Response to Reviewer #2 Comments

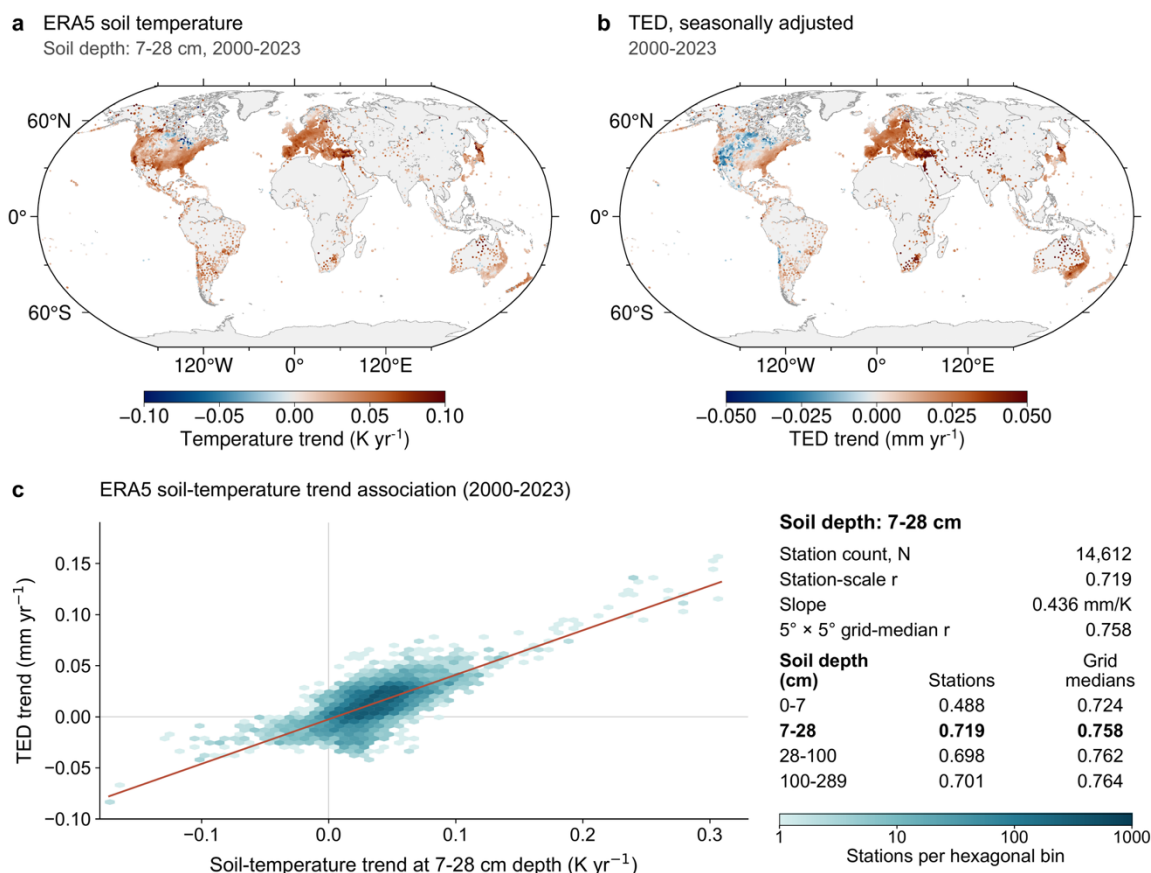
Comment 1: The main concern I have now, and I did not pay attention to last time, is the trends evident in Fig 4. I think the authors must say what is causing this. Is it that the model has not reached steady state at the beginning? or is this spurious ERA5 trends? The latter is trivial to compute, and I think the authors should show a map of trends in ERA5 over the data period (or just over 2000-2023) and the map of trends estimated from the model. The trends shown are small ($<0.05\text{mm/yr}$), but they may well be spatially systematic and hence bias entire continents in the same direction.

Response 1: Thank you for pointing out this issue. We agree that the trend-like variations visible in Fig. 4 need further explanation. In the revised manuscript, we have added an analysis comparing the long-term trends in the ERA5 soil-temperature forcing and the corresponding TED series during 2000–2023 (new Fig. 5).

The comparison shows that the spatial patterns of the TED trends are generally consistent with those of the ERA5 soil-temperature trends. The strongest relationship is found for the 7–28 cm soil-temperature layer, with a Pearson correlation coefficient of 0.719 at the station scale. The correlation increases to 0.758 when the data are averaged within $5^\circ \times 5^\circ$ grid cells. These results suggest that the low-frequency variations in TED are mainly related to long-term variations in the temperature forcing and the associated subsurface thermal response.

We have also revised the manuscript to note that trends fitted to TED time series should be interpreted with caution, as they may reflect long-term variations in the temperature forcing and uncertainties in the input datasets.

“The representative time series in Fig. 4 also show low-frequency variations that appear as trend-like signals over the 2000–2023 period. To examine their possible origin, Fig. 5 compares the long-term trends in ERA5 soil-temperature forcing with those in the TED series after removing the annual and semiannual components. The spatial pattern of TED trends is broadly consistent with that of the ERA5 soil-temperature trends, particularly over continental regions with pronounced long-term temperature variations. Among the four ERA5 soil-temperature layers, the 7–28 cm layer shows the strongest station-scale relationship with TED trends (Pearson $r = 0.719$). This relationship becomes slightly stronger when evaluated at the $5^\circ \times 5^\circ$ grid-cell scale ($r = 0.758$). These results indicate that the low-frequency variations in TED are closely associated with long-term changes in the temperature forcing and the resulting subsurface thermal response.”
